PM Dec 2018 Glitch & Fix

Sometimes Warm, Other Times Not So Much...

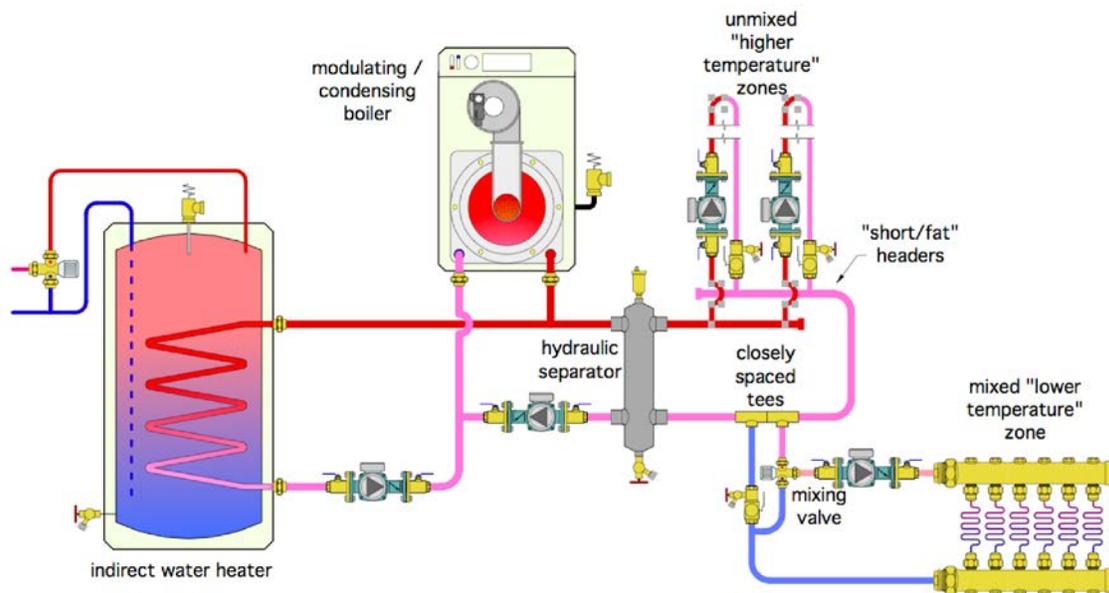
The Glitch: Eager to keep up with this new technology, an installer decides to install a hydraulic separator between a boiler and distribution system as shown below. The space heating loads consist of two “unmixed” zone circuits, and one mixed zone circuit. The installer connects the unmixed higher temperature loads upstream of the mixed lower temperature load. All the load circuits are supposed to operate independently. The indirect water heater is operated as a priority load.

When the system was turned on, there was very little warmth from the low temperature loads. What's the problem? Can you also spot a few more missing or incorrect details?

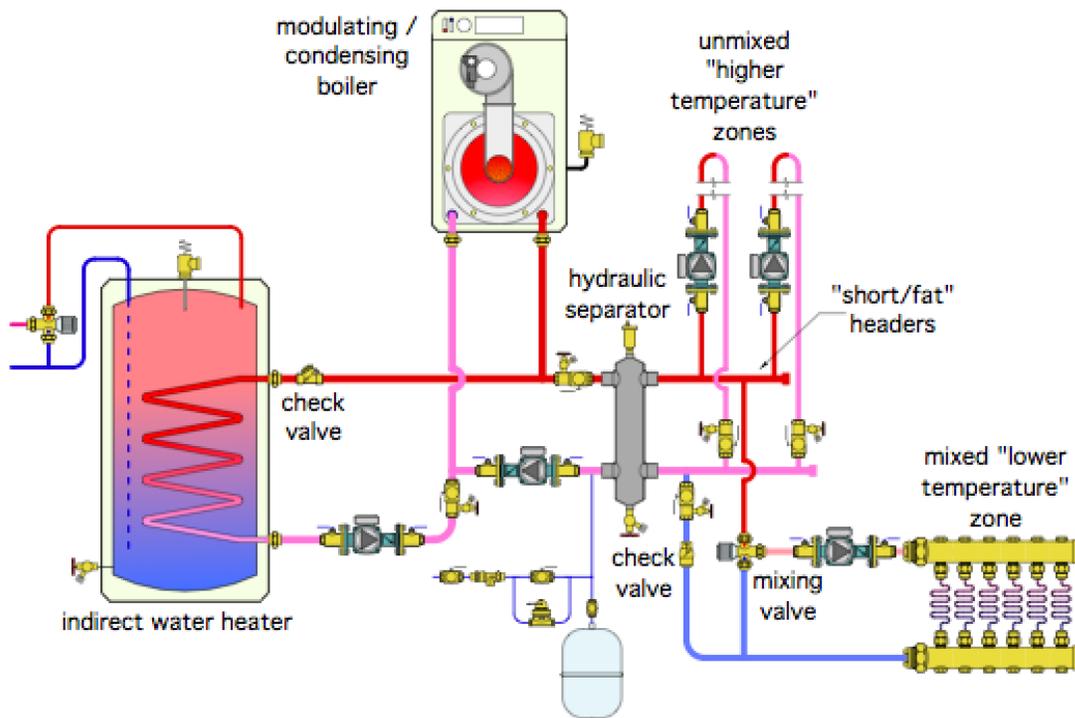
Using closely spaced tees downstream of the hydraulic separator adds a second unnecessary and undesirable hydraulic separation between the lower temperature “mixed” circuit and the hydraulic separator. The lower circuit will only receive heated water when the circuits connected across the header are active. At other times the water returning to the lower header will simply make a U-turn and be drawn back into the hot port of the mixing valve. The solution is simple: Pipe all the loads across the headers as shown in the fix drawing.

Other errors in the original system, that have been corrected in the fix drawing include:

- Lack of an expansion tank and make up water assembly
- Upside down purging valve in the wrong location on the lower temperature circuit
- Lack of properly placed purging valves
- Adding a properly placed check valve on the return side of the lower temperature load - since that load is now connected across the headers.
- Adding another check valve on upper coil inlet of indirect tank to minimize thermosiphoning along the upper pipe.

The Fix: A hydraulic separator eliminates the need to use closely spaced tees when connecting load circuits. All load circuits can be piped across the headers. Those headers should be short, and generously sized. This keeps the pressure drop along the length of the header extremely small (e.g. negligible). The slow flow rate along the vertical height of the hydraulic separator adds virtually nothing to this pressure drop. Thus, the differential pressure between the upper and lower headers is essentially zero. Each load connected across the headers is

unable to detect the presence of the other load circuits.
